# **Product Change Notification**

**Change Notification #: 113834 - 00**

**Change Title:**            **Boxed Intel® Compute Stick  
STCK1A32WFCR  
PCN 113834-00  
Label  
Add a warning label and update the  
rating label**

**Date of Publication:**    **May 1, 2015**

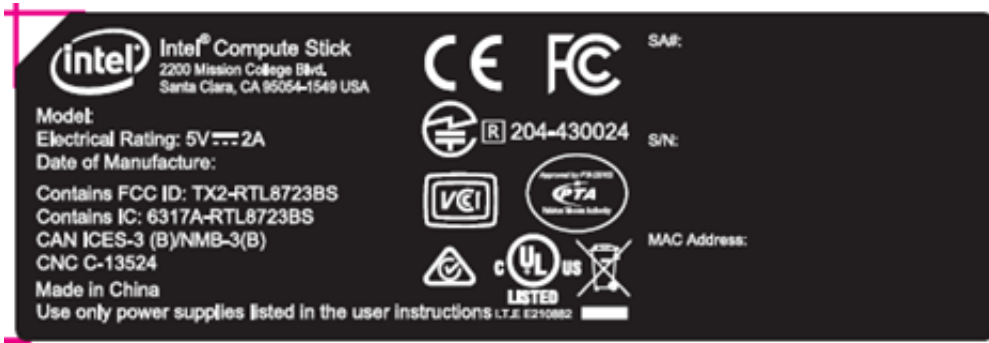
A required warning label will be added to the packaging for the included USB cable. See below for the warning label location and text.

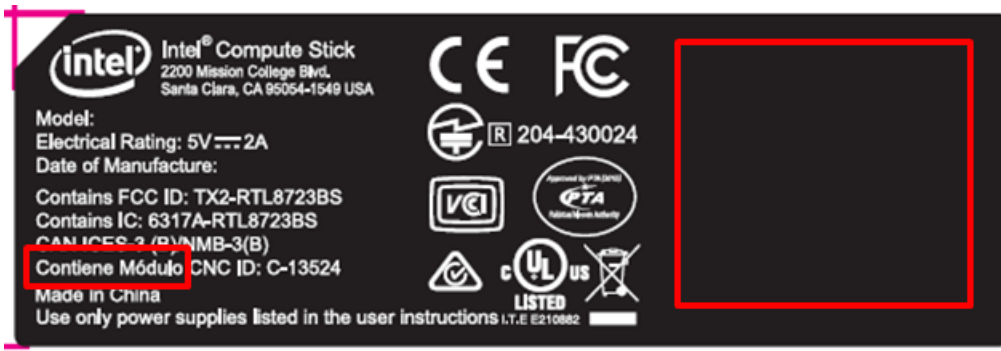
The rating label will be updated to add Argentina ID. See before and after labels below:

**Before**

**After**
